RE: Hayward Park Review

Plan Review Comments
HAYWARD PARK
CANNON DESIGN GROUP
October 1, 2019

Preliminary Review Comments
HAYWARD PARK
CANNON DESIGN GROUP
June 21, 2019

CONCERN #1: TRANSIT STATION REPLACEMENT PARKING

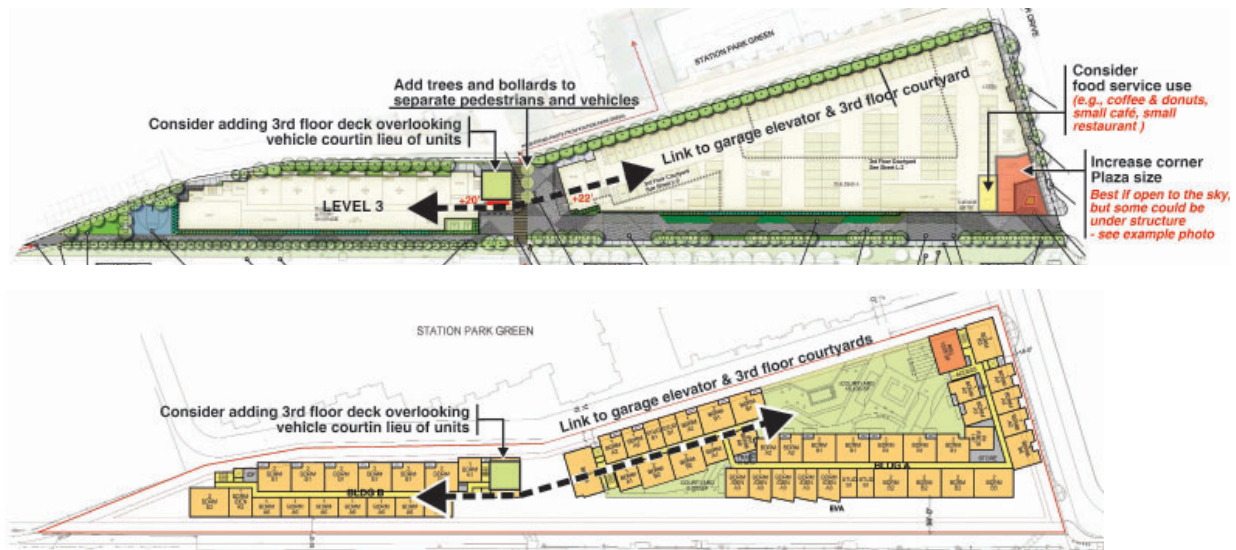
The applicant has proposed including approximately 40 parking spaces for transit riders and leasing office use immediately inside the garage. It would be separated from resident parking by a drive aisle gate. The final number of parking spaces will be based on the Consultant/City analysis and the adopted Caltrain Business Plan.

CONCERN #4: DELIVERIES AND RIDE SHARING

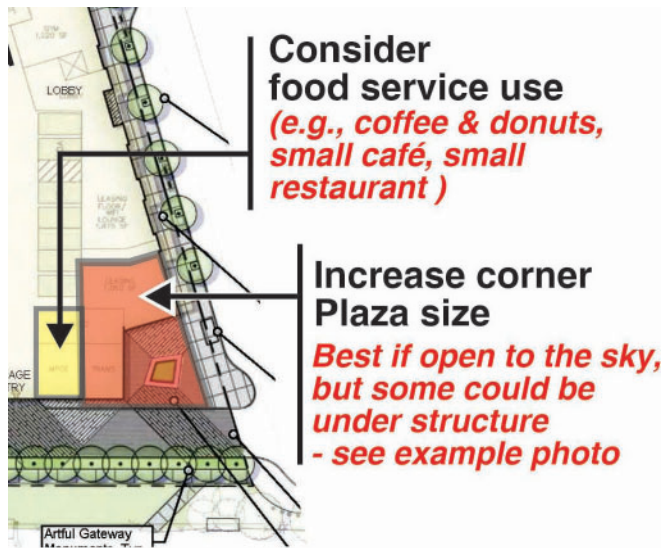
The applicant is reportedly studying concepts to address these issues. My understanding is that they would still likely require the short term parking for these activities to be located on Concar Drive in the area now devoted to the transit station drop off and bus stop. Deliveries might be given some designated space near the leasing office to store packages for tenant pick up, but that would then require either Building B tenants to pick up items there or management staff delivering packages to the tenants' units. For ride sharing services, there would still be a significant inconvenience, and a not-so-pleasant or weather protected path from Building B units to the Concar Drive frontage. Any proposed design should prioritize creating the least amount of impact along Concar Drive.

Another approach might be to allow these service vehicles to access the service court between Buildings A and B via the westerly EVA. If that option were to be explored, the applicant should refine the pedestrian and vehicle circulation plans and Plaza amenities.

CONCERN #5: OPEN SPACE PLAZA

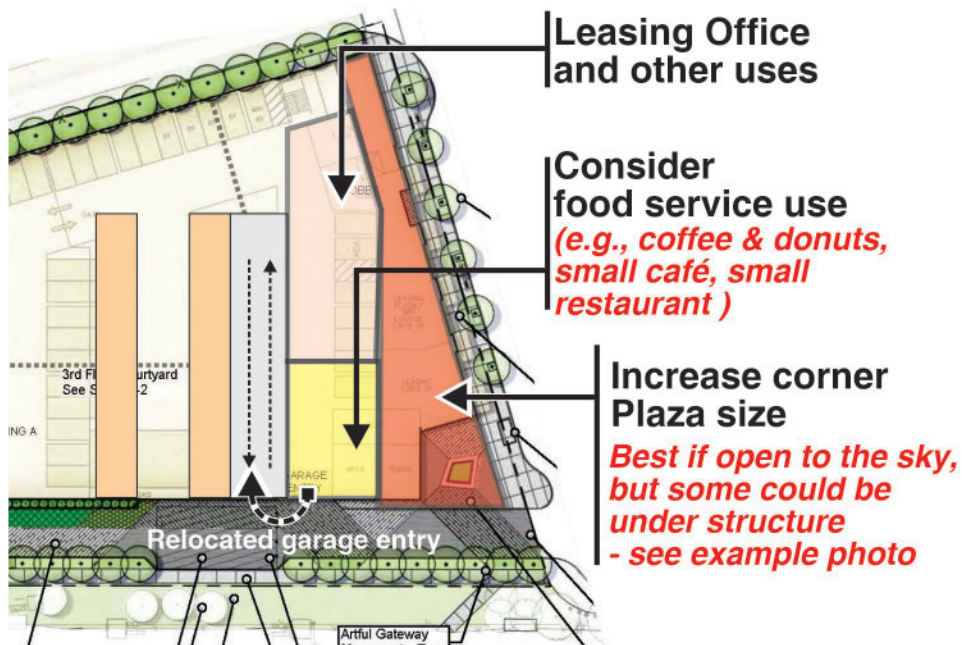
The commissioners uniformly expressed concerned with the small size of the proposed open space Plaza at the southwest corner of Building A. The options are limited

- A. Increasing the Plaza size at the corner and adding a food service use to serve tenants and transit riders. The Plaza would be increased in size to approximately 2500 square feet - about one-half the requirement included in the TOD development plan. This would be best if open to the sky, but some portion of the Plaza adjacent to the food service use could be tucked under the building - see the Santa Monica multifamily housing example photo below.

CONCERN #6: TWO-STORY PARKING GARAGE WALL

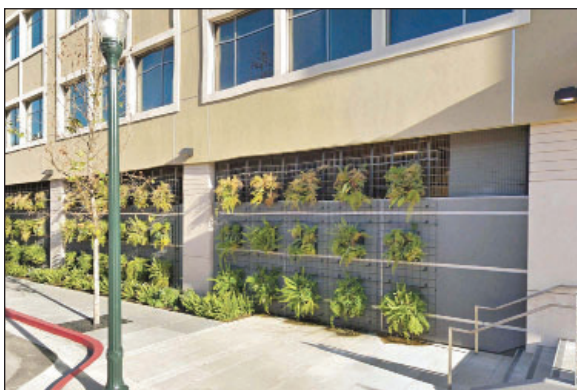
One approach was covered in the addressing of Concern #3 above (reducing above grade parking to one level). The green wall approach shown by the applicant is one way to address the concern, but it would still seem like a long continuous two-story tall wall. Other approaches would be to break the wall up into smaller segments similar to the scale of the residential units by expressing a structural framework or by breaking the landscaping into more substantial elements. These two approaches are shown in the photos below.

CONCERN #8: ARCHITECTURAL DESIGN

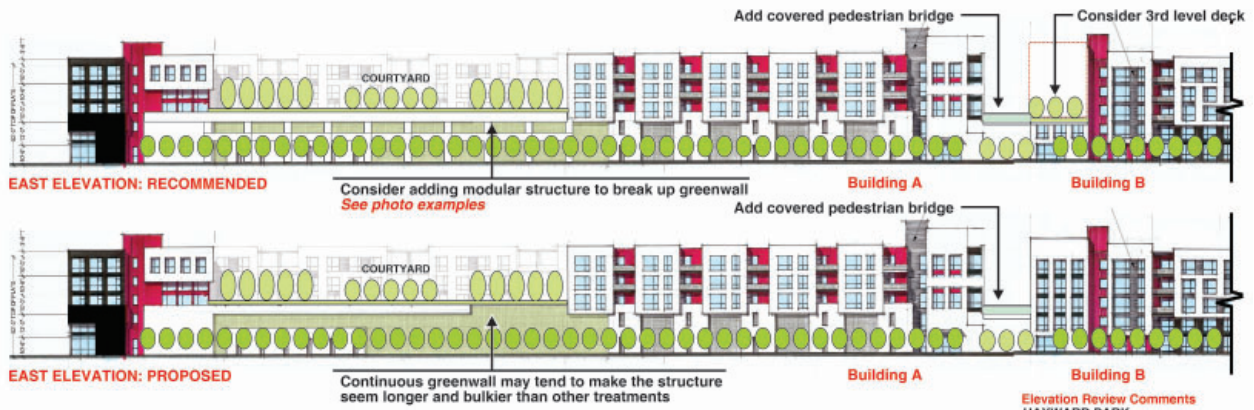
- A. East Elevation: The issues addressed above for the two-story garage wall and the pedestrian bridge between Building A and B are shown on the partial East elevation below.

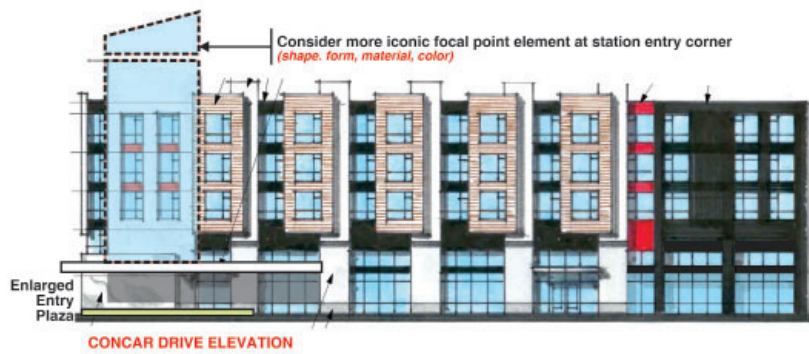
- B. West Elevation: The railroad corridor elevation of Building B is quite long and the projecting bay element is of a much larger scale than the majority of the other building facades. A similar concern relates to the southern portion of the west facade of Building A. One approach would be to articulate these facades in a manner similar to the east facades. A second minimum solution, shown below, would be to break the long projecting elements into smaller segments.

- C. Consider designing a more iconic focal point at the station entry corner of the Concar Drive facade to emphasize the transit station- a couple of photo examples are shown below, but many other approaches could be appropriate

SHEET 1

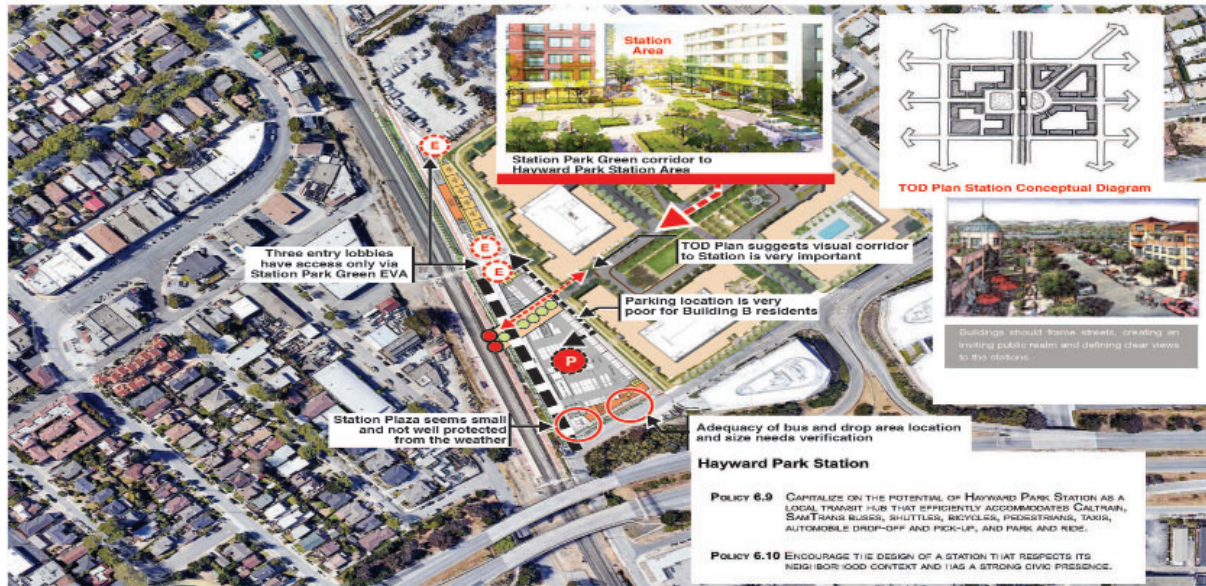
1. The proposed project does not include the station access and parking configuration called for in the TOD Plan between the project and the CalTrain Station.

2. The TOD Plan envisioned a direct pedestrian link between the Station Park Green open space and the CalTrain Station to support direct access and to more strongly link the residential developments to the station.

3. The project proposes consolidating all CalTrain Station bus and automobile access to the south side of the property. It is unclear whether this curb side service area is adequate.

4. The parking and bus parking provided along the south side of the site along Concar Drive combined with the placement of Building A relative to Concar Drive limits the amount of sidewalk and landscaping linking Station Park Green with the CalTrain Station. It appears that the Concar Drive frontage would be narrower and less landscaped than the sidewalk along RE 2 residential block at Station Park Green.

5. An EVA on the Station Park Green western frontage separates the two projects. The frontage along the Station Park Green side of the EVA is substantially landscaped while the proposed project frontage treatment appears limited to street trees and some bioretention landscaping along the face of Building B.

6. All parking is provided above grade which limits the treatment of the Building A lower two floors along the eastern EVA. While this matches the above grade parking approach used in Station Park Green, the office structure nearby across Concar Drive has underground parking.

SHEET 2

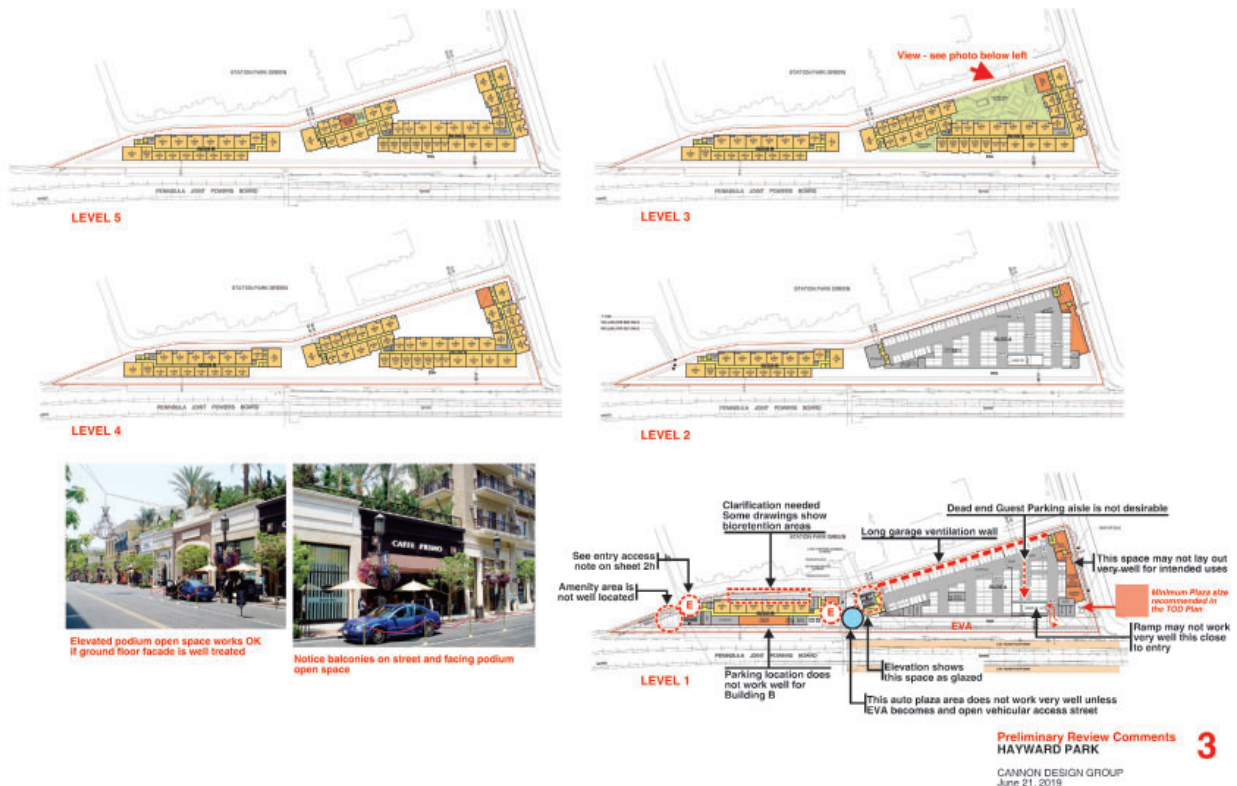
1. Residents in Building B will have poor access to the parking which is totally contained within Building A.
2. If the EVA between the project and Station Park Green remains limited to pedestrians and emergency vehicles, the two entries to Building B and the northern entry to Building A facing the EVA will not have direct auto access for drop off and deliveries.
3. The at-grade publicly accessible open space adjacent to Concar Drive is small, and does not seem to conform to the design concept or minimum size guidelines shown in the TOD Plan.
4. As noted on Sheet 1, the pedestrian link between Station Park Green and the CalTrain Station does not appear to conform with the TOD Plan.

SHEET 4

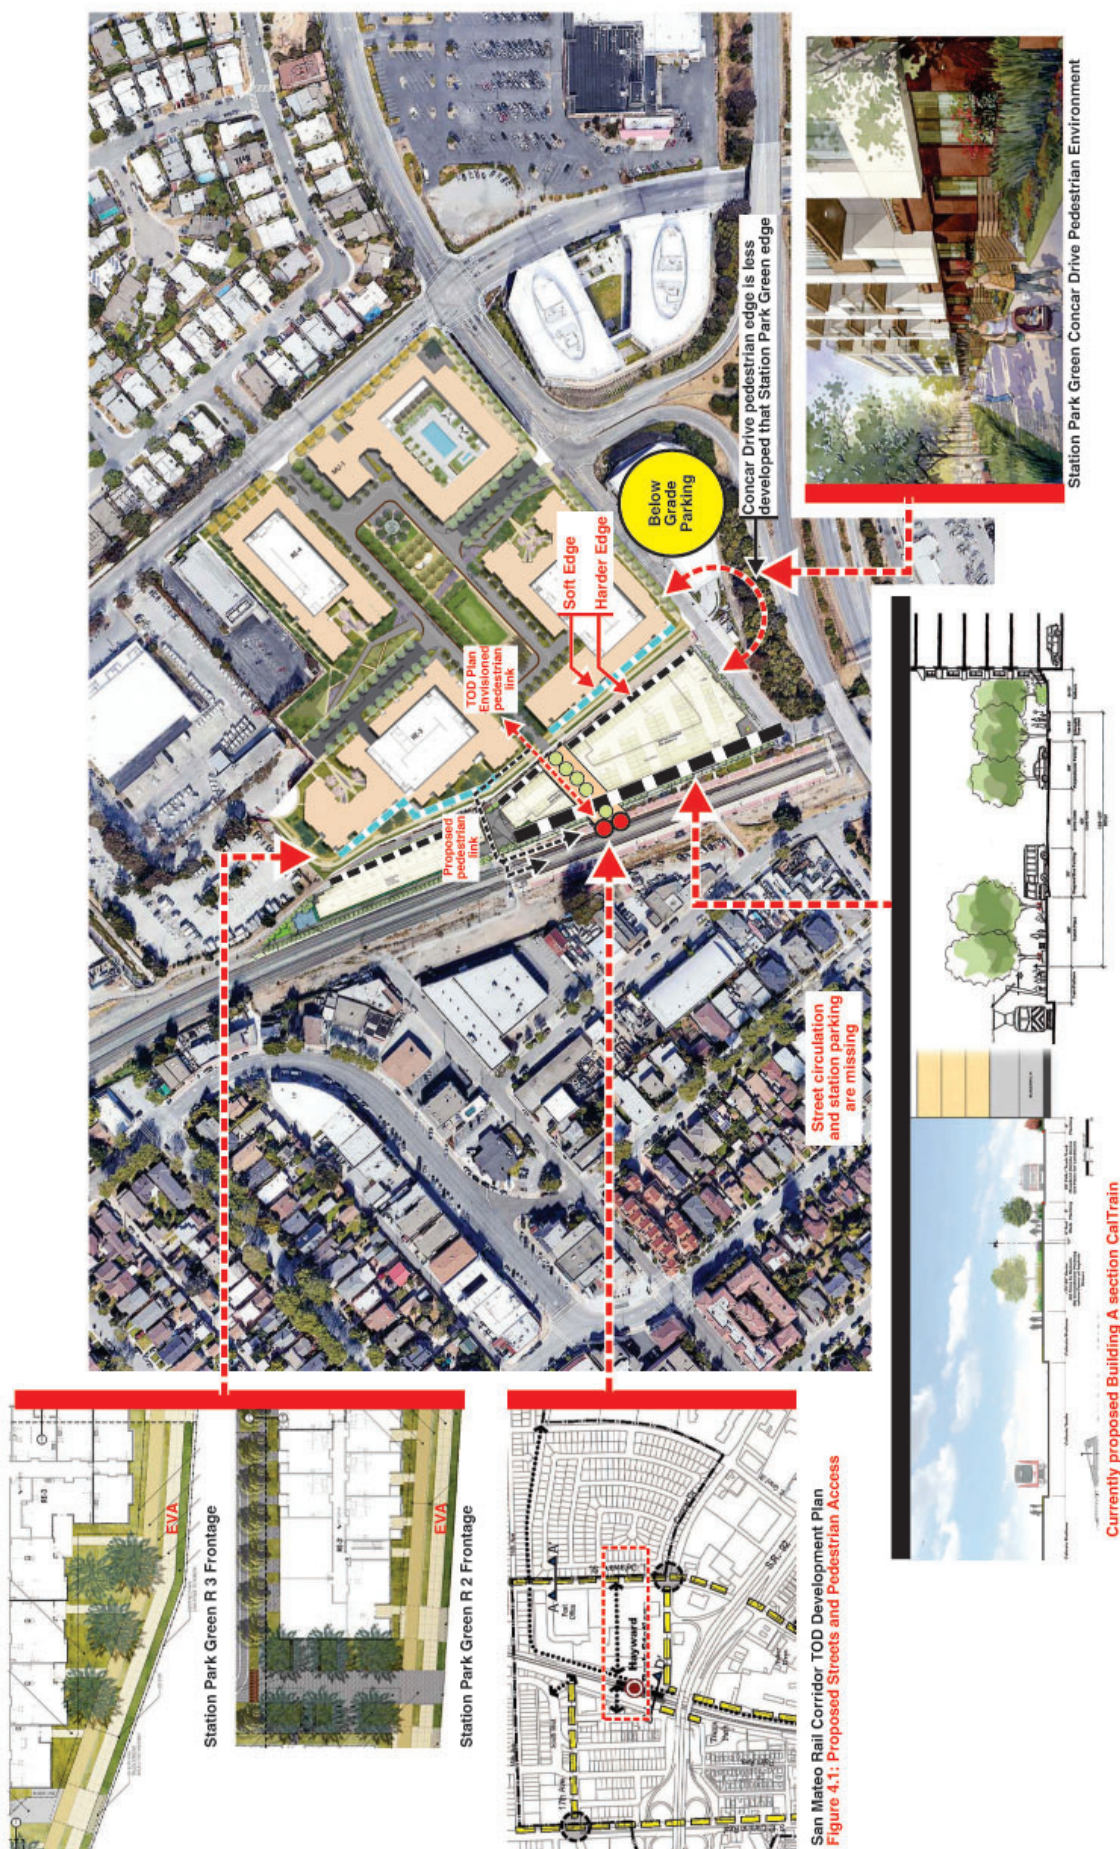
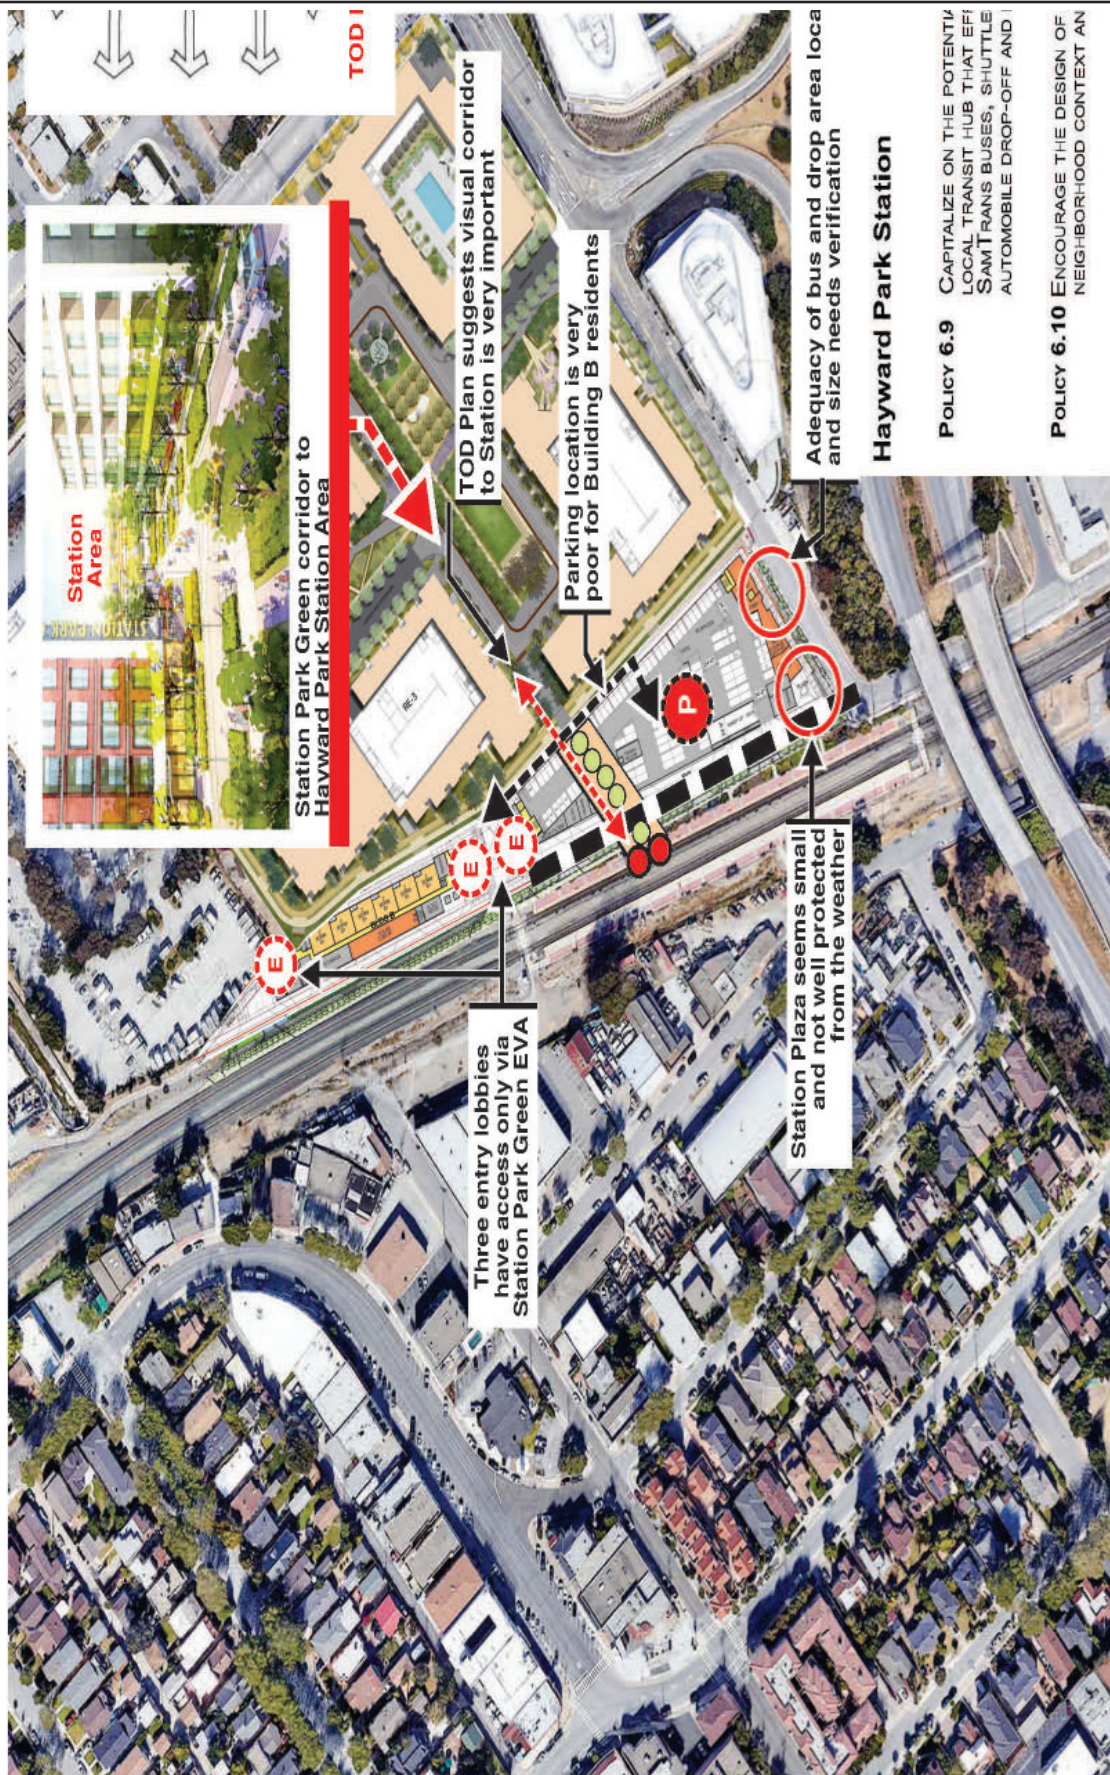
There are parts of the elevations that work well, but other parts could benefit from further refinements. The Concar Drive facade is well designed with a good balance of articulated vertical bays and some simpler end cap forms. The combination of the same sawtooth vertical bays with smaller and less articulated box forms also offers promise. The areas that seem to work less well include the following:

1. The railroad corridor facing elevations are rather long, and fairly flat. In comparison, the longest office facade facing the rail corridor in the office portion of Bay Meadows is shorter, and it, along with the other office buildings along the rail corridor are broken up by significant facade recesses to separate the buildings into two distinct elements - see Bay Meadows aerial photo on Sheet 5.
2. The lower two floors of garage facade on the east face of Building A are not well integrated into the building or the surrounding pedestrian-oriented fabric of Station Park Green. It might be better to develop this facade with storefront-scaled modules that better subordinates the garage screening. One example that did that at the second floor level of the garage is the recently approved Essex Project on Fifth Avenue downtown - see illustration below.

3. The introduction of fiber cement siding is probably a good idea, but the logic of its placement and integration into the overall design is not clear.
4. The space between Buildings A and B doesn't seem well developed yet. The lower floor at the lobby for Building A shows glass on the elevation and the sketch on Sheet 5, but the floor plan shows bike storage in that location. The sketch of this area on Sheet 5 show material and color changes that help reinforce the importance of the buildings facing the pedestrian link, but those treatments are not shown on the elevation.

Deceptive image: Floor plan shows bike store on ground floor corner

This facade is very well balanced between vertical residential bays and simpler end caps
